Service Bulletin

Bulletin No.: 17-NA-231

Subject: Information on the Replacement of the Video Processing Module Due to Water Intrusion

4291116

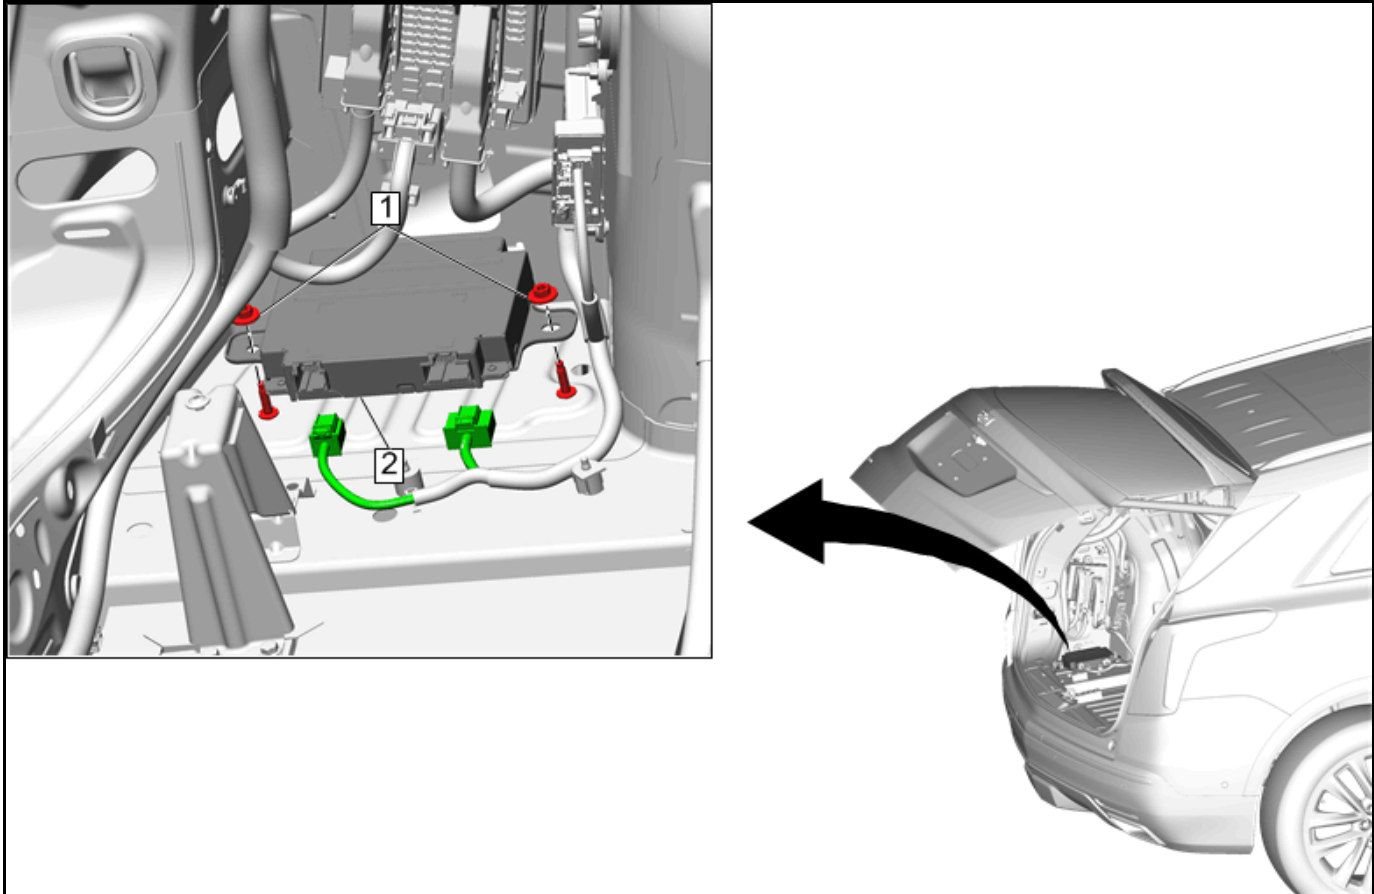
2. Install 2 washers for each stud used to mount the video processing unit.

Note: Be sure to install the washers under the video processing unit, so that the unit is raised from the installation of the washers.
